**REVISED AGENDA**  
**FOR THE CITY OF OLIVETTE**  
**PLANNING AND COMMUNITY DESIGN**  
**COMMISSION**  
**MEETING OF OCTOBER 27, 2016**  
**AT 7:00 P.M.**  
**IN THE LECTURE ROOM**  
**AT OLIVETTE COMMUNITY CENTER**  
**LOCATED AT 9723 GRANDVIEW DRIVE**

**DATE:** OCTOBER 20, 2016  
**TO:** PLANNING AND COMMUNITY DESIGN COMMISSION  
**FROM:** CARLOS TREJO, AICP  
DIRECTOR OF PLANNING AND COMMUNITY DEVELOPMENT  
**RE:** CHEVY'S FRESH MEX  
9119 OLIVE BOULEVARD  
PETITION FOR SITE PLAN & COMMUNITY DESIGN REVIEW FOR CANOPY

## STAFF REPORT: 9119 OLIVE BOULEVARD – CHEVY'S FRESH MEX

**DATE:** OCTOBER 20<sup>TH</sup>, 2016  
**TO:** PLANNING AND COMMUNITY DESIGN COMMISSION  
**FROM:** CARLOS TREJO, AICP  
DIRECTOR OF PLANNING AND COMMUNITY DEVELOPMENT  
**RE:** 9761 LINDLEY DRIVE  
PETITION FOR COMMUNITY DESIGN REVIEW & SITE PLAN REVIEW

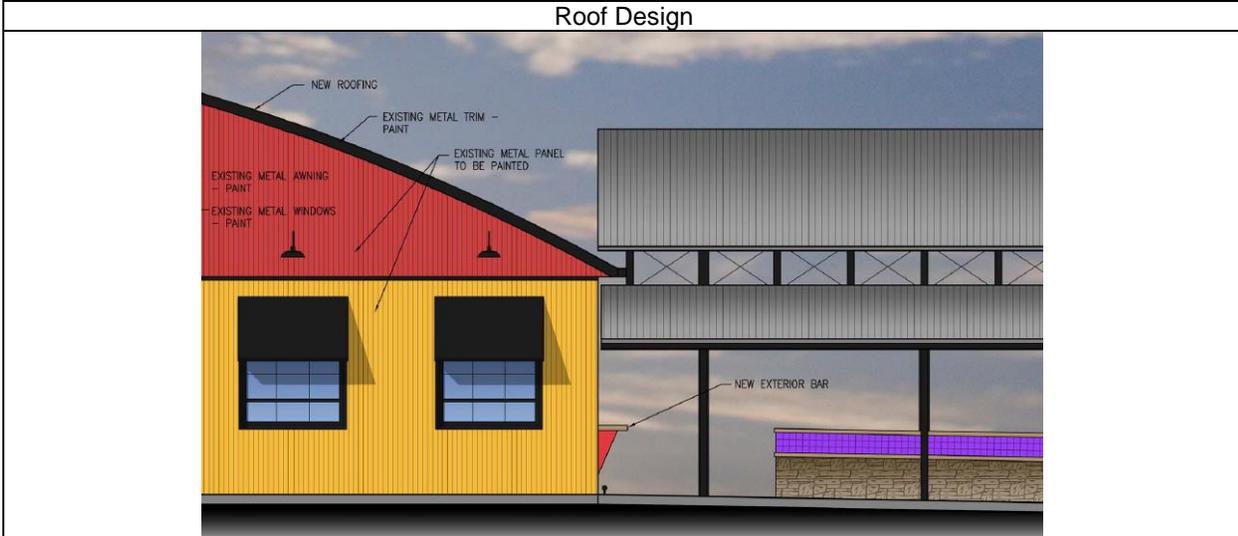
The proposed canopy does not modify the existing landscaping, pedestrian areas, or streetscape edges. The roof of the canopy will be setback at least 9-feet from the nearest building edge towards Olive Boulevard.

*Masses and Voids.* The proposed canopy will be setback 9-feet from the primary building wall facing Olive Boulevard. The height of the proposed canopy is 6-feet lower than the primary roof.

**South Streetscape View from Olive Boulevard - Current**

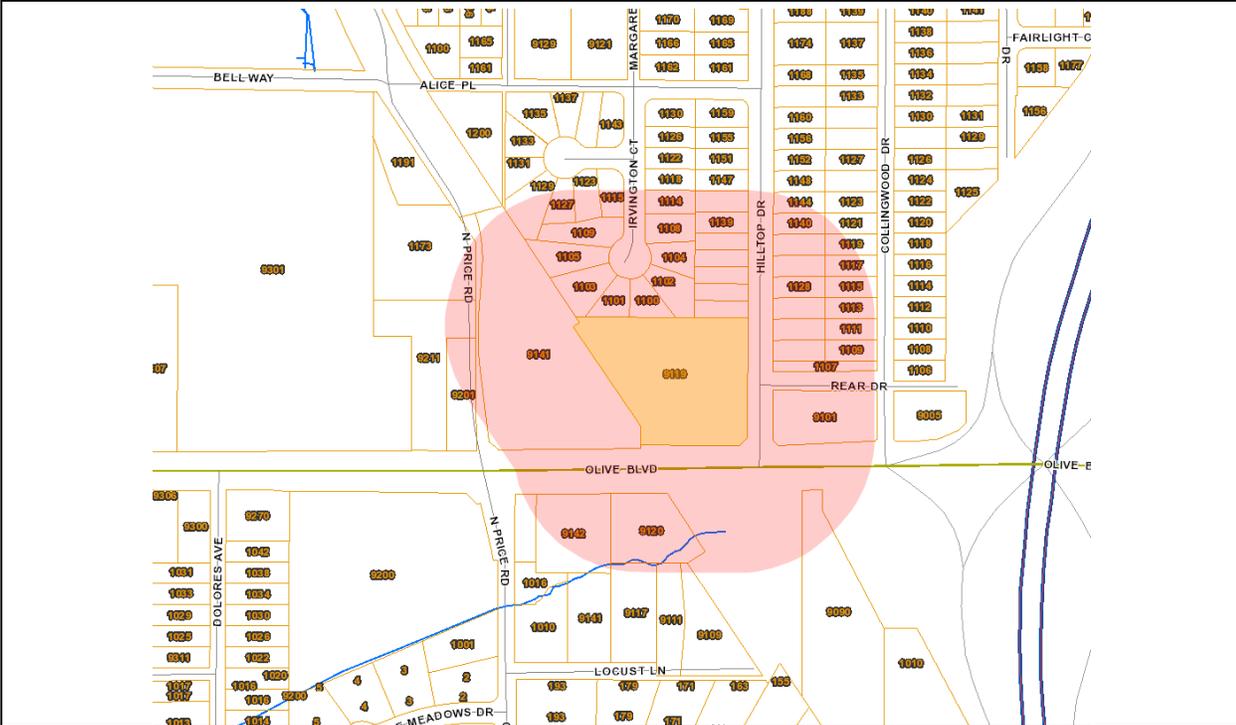
*Roof Design.* The proposed plans include a pre-finished arched canopy roof with two pre-finished metal shed roofs jutting out from the sides of the main canopy. The height of the main canopy is 6-feet lower than the top of the primary roof. The primary arched canopy is similar to the arch roof of the primary structure.

The top of the secondary pre-finished metal shed roof is 13-feet in height. The height of the roof is similar to the break in the existing metal panel wall on the front of the building facing Olive Boulevard.

**Signage.** A new wall sign centers the on canopy roof. Staff measures the wall sign to be 29 square feet. The sign mimics the existing south facing wall sign that is visible from Olive Boulevard. Staff finds the signage compatible with the building design and exterior.

SHEET TITLE: SITE PLAN

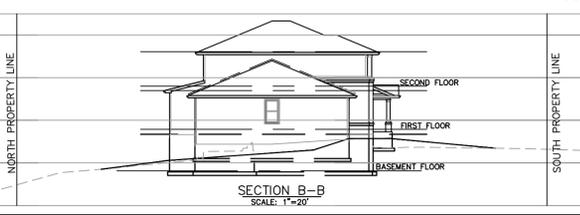
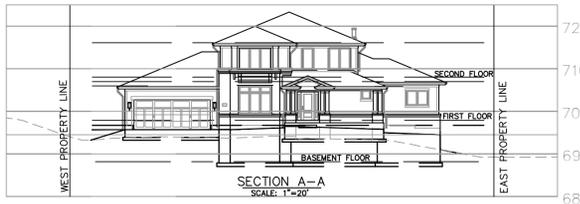
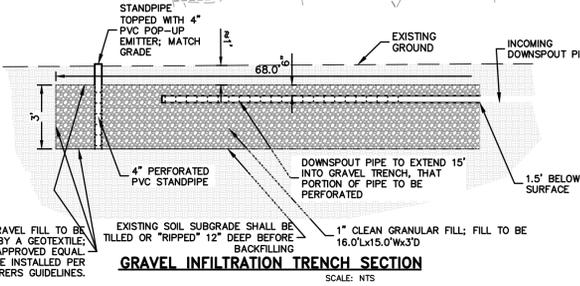
1. The Commission approved the Petition for Community Design and Site Plan Review on April 21<sup>st</sup>, 2016 with the condition the Petitioner provide a revised Stormwater detention area.
2. The proposed detention area captures an area sized for the proposed roof area of the home.
3. During the review process, staff noted to the engineer the placement of the detention area may impact the root system of the tree.
4. No formal action by the Commission is required.
